Use Form 3160-3 (APL					
SUBMIT IN TRIPLICATE - Other instructions on page 2.			7. If Unit of CA/Agi	reement, Name and/or No.		
1. Type of Well						
Oil Well Gas V	Vell Other			8. Well Name and N	PAISANO FEDERAL #1

2. Name of Operator JALAPENO	CORPORATION			9. API Well No.	30-005-63840	•.
3a. Address P.O. BOX 1608, ALBQUERQUE	E, NM 87103	Phone No. (inclu 505-242-2050	· ·	10. Field and Pool o Wolf Lake, Sar	r Exploratory Area n Andres, South

SCHEMATIC PRIOR TO PLUG AND ABANDON
JALAPENO CORPORATION
PAISANO FEDERAL #1
CHAVES COUNTY, NEW MEXICO
API NO. 30-005-63840

Permanent Abandonment of Federal Wells Conditions of Approval

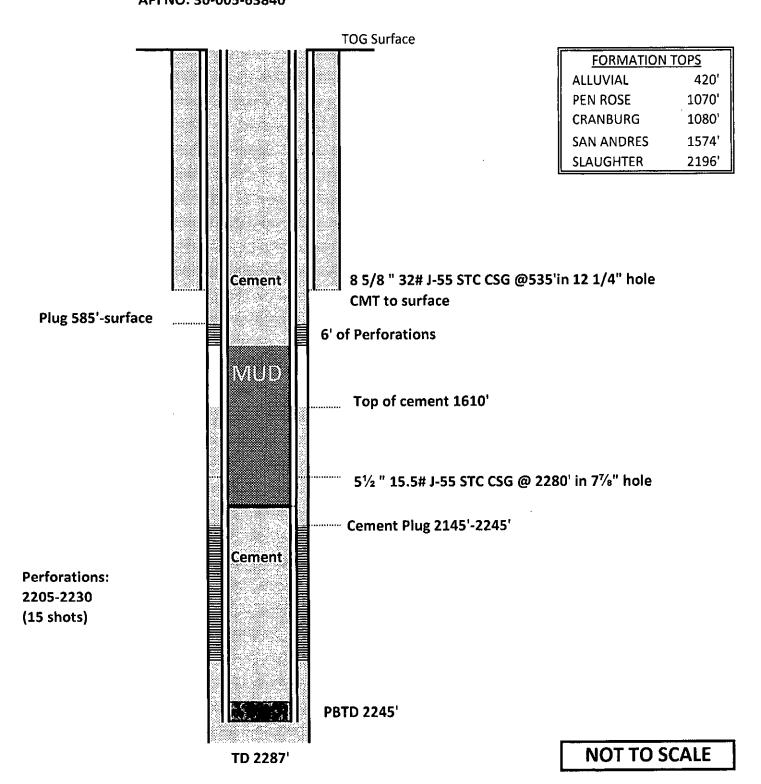
12. CHEC	CK THE APPROPRIATE BOX(ES) TO INDICATI	NATURE OF N	OTICE, REPORT OR OT	HER DATA	
TYPE OF SUBMISSION			TYPE OF	ACTION		
Notice of Intent	Acidize	Deepen Deepen		Production (Start/Resume)	Water Shut-Off	
<u></u>	Alter Casing	Fracture Tre	at 🔲	Reclamation	Well Integrity	
Subsequent Report	Casing Repair	New Constr	iction 🔲	Recomplete	Other	
Cussiquent report	Change Plans	Plug and At	andon 🔲	Temporarily Abandon		
Final Abandonment Notice	Convert to Injection	Plug Back		Water Disposal	·	
		S WELL. HOWE	/ER, WE CONTI	INUED TO PRODUCE 1	THE WELL BEYOND THE F	
PBTD OF THE WELL IS 2	245'. WE PROPOSE TO:				5.00 m m m

1. SET A CEMENT PLUG FROM PBTD TO 50FT ABOVE TOP PERFORATIONS (APPR. 2142. WAIT FOR CEMENT TO DRY AND TAG AT OR ABOVE 2145. 3. FILL HOLE WITH MUD 50FT BELOW SURFACE SHOE. 4. PERFORATE 50FT BELOW SURFACE SHOE AND CIRCULATE CEMENT HOLE TO SUF 5. WAIT FOR CEMENT TO DRY.			·	NM OIL CON: ARTESIA D APR 1 8	ISTRICT

6. SET DRY HOLE MARKI				·.*:	RECEIV	/Pm
,	Accepted for reco			OR_ 3 _MONTH L 1 4 2016	1 PERIOD	VED
14. I hereby certify that the foregoing is t	rue and correct. Name (Printed/T	yped)
